SERVICE INFORMATION LETTER

Subject: Installation Recommendations for Wencor Tubular Rivet PN 800162WE, installed in the JT8D Engine 7th Stage High Pressure Compressor (HPC) Disk.

Figure 3, Showing Undesirable Gap Under Rivet Head

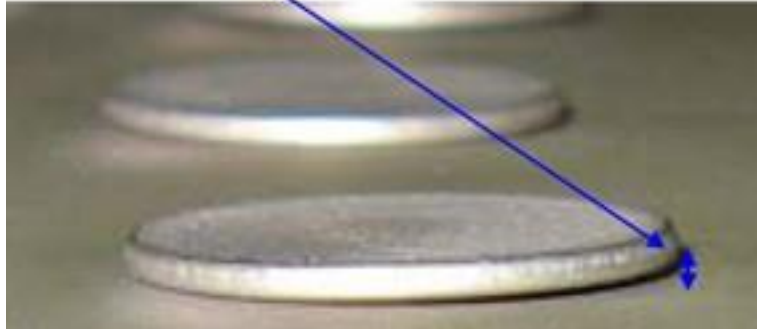
As shown below in Figure 3, examination of some rivets still installed in the disk showed that the rivet heads were not setting flat or parallel against the blade pin or disk surface after installation. This results in a gap between the underside of the rivet head and top side of the blade pin. Wencor considers any gap that is larger than .003" a contributing factor that could cause stress in the rivet radius that could contribute to head liberation.

Any gap over .003" is undesirable

Figure 5, Witness Marks Showing Incomplete Rivet Head Support

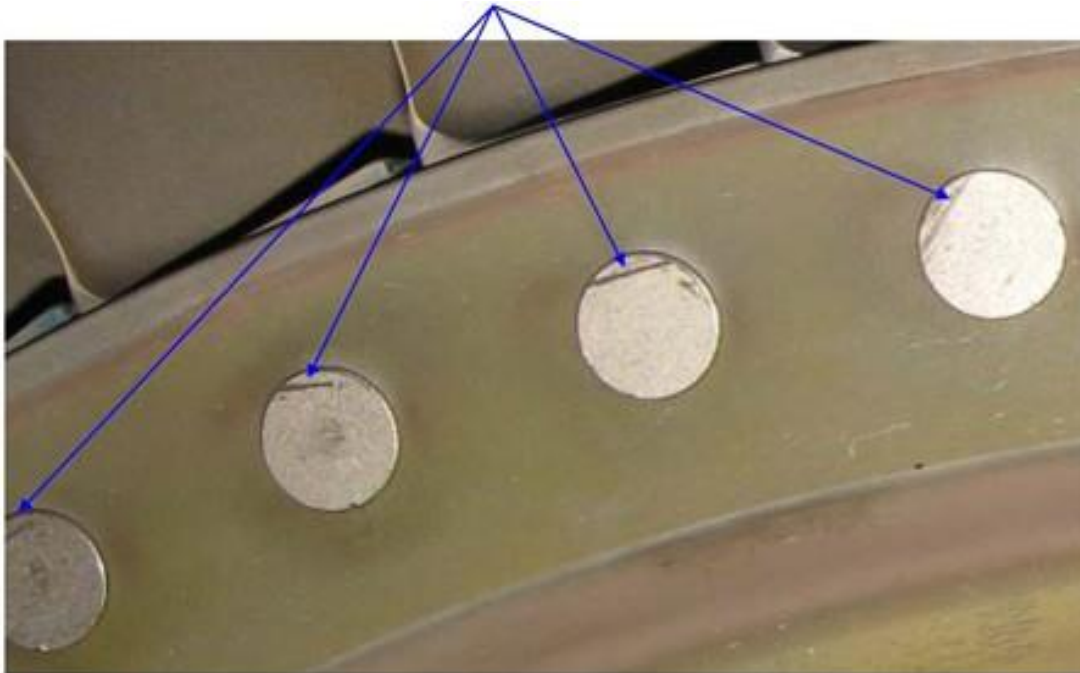
During the rivet flaring process, the rivet head is supported by a tool that incorporates a mandrel that should support the entire rivet head while the rivet is flared (see Figure 6 & 7). As shown below in Figure 5, examination of some of the rivets still installed in the disk showed evidence of incomplete support of the rivet head during the flaring process. If the entire rivet head is not supported during the flaring process, a bending stress would be generated at the rivet radius which could contribute to head liberation.

Figure 6, 7th Stage Disk Assy Set Upon Support Tool

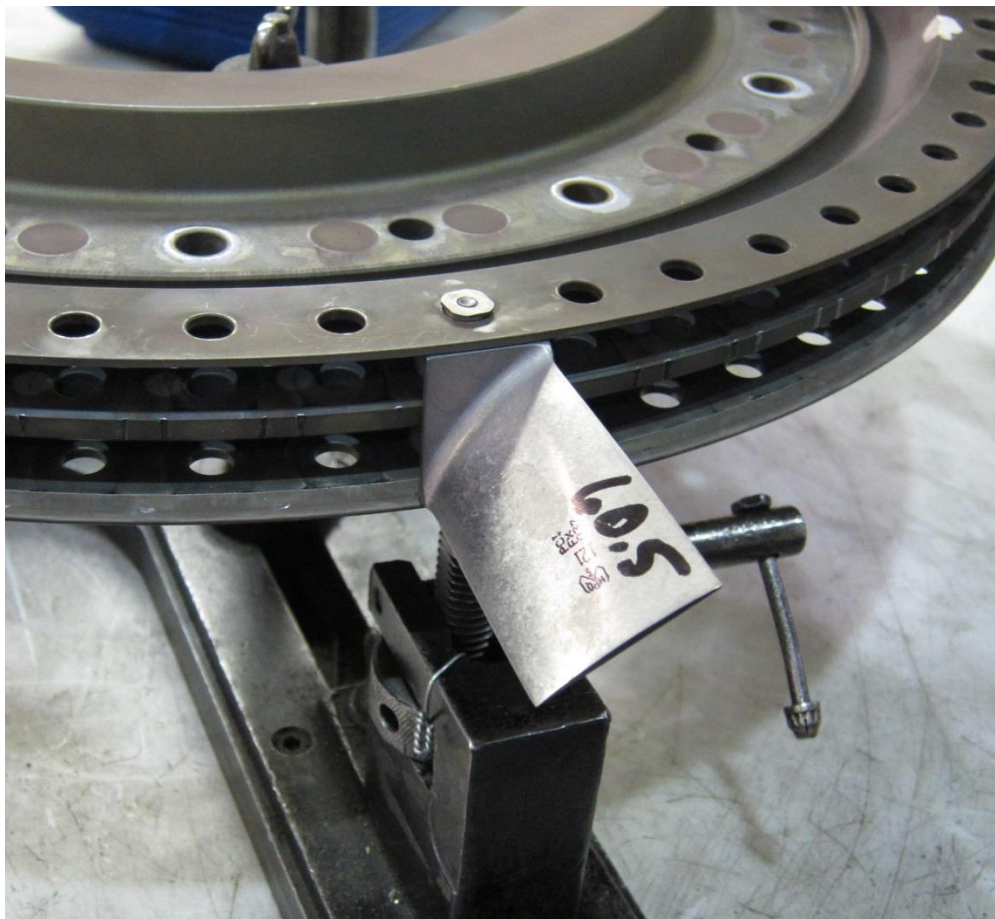
During the rivet flaring process, when the rivet is installed into the 7th stage disk and the disk is set upon the disk support tool (PWA 33565) as shown below in Figure 6 and described in step 1 of task 72-36-02-44-003-002 (JT8D-1/17 EMM for PN 481672) or in task 72-36-02-44-003-003 (JT8D-209/219 for PN 773128). Prior to flaring the rivet, the rivet head must be fully supported by the mandrel as shown in Figures 7 & 7a.

Figure 8, Installed Rivet with .003” Max Gap Under Head

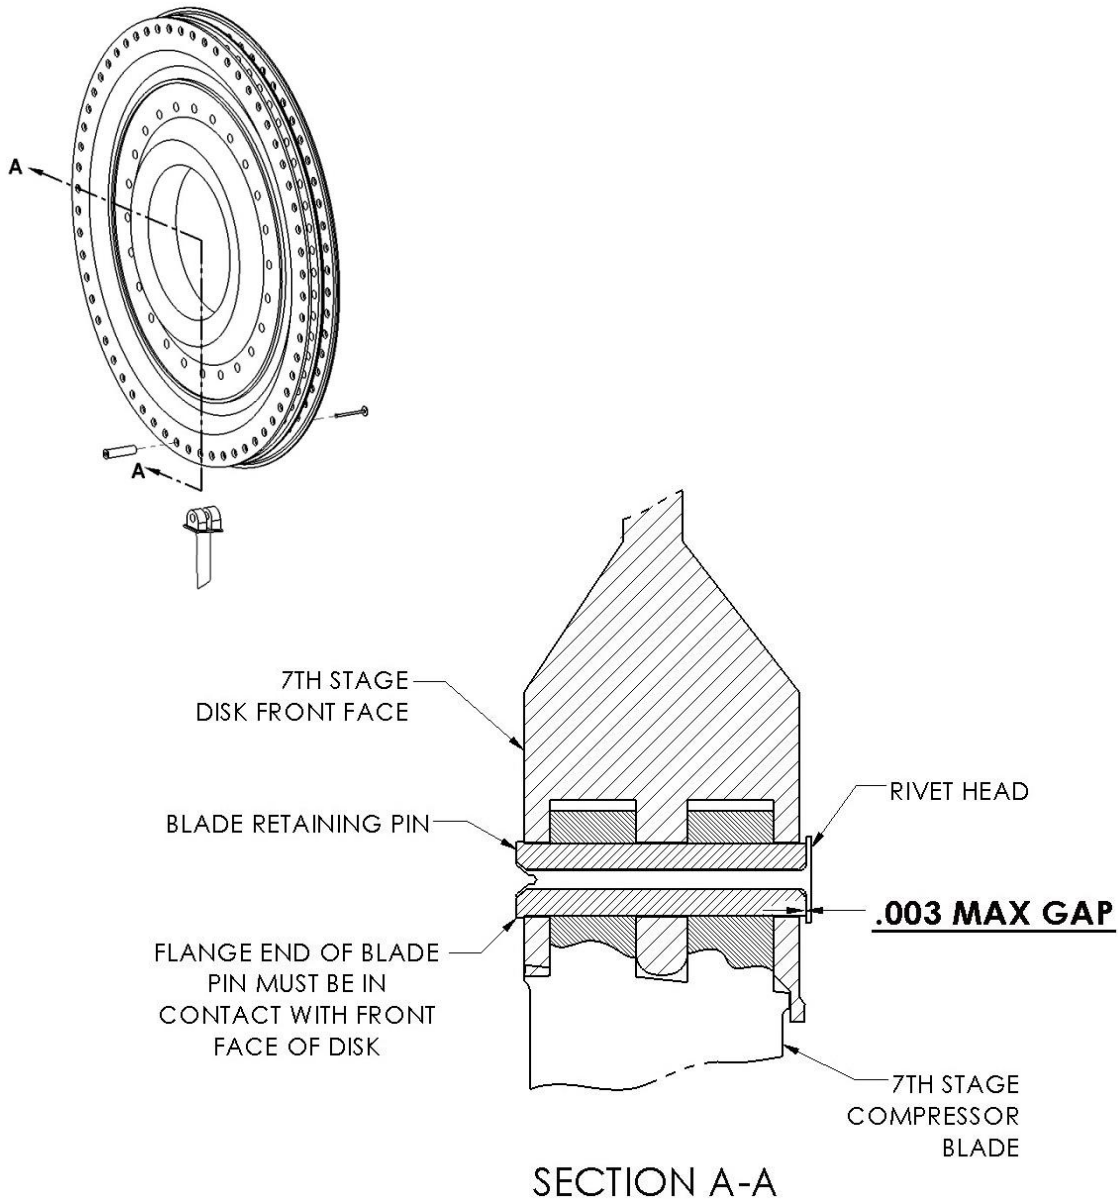
After the rivet flaring process, during step 2 of task 72-36-02-44-003-002 (JT8D-1/17 EMM for PN 481672) or in task 72-36-02-44-003-003 (JT8D-209/219 for PN 773128), verify that the gap between the rivet head and the blade pin as shown in Figure 8 does not exceed .003”.
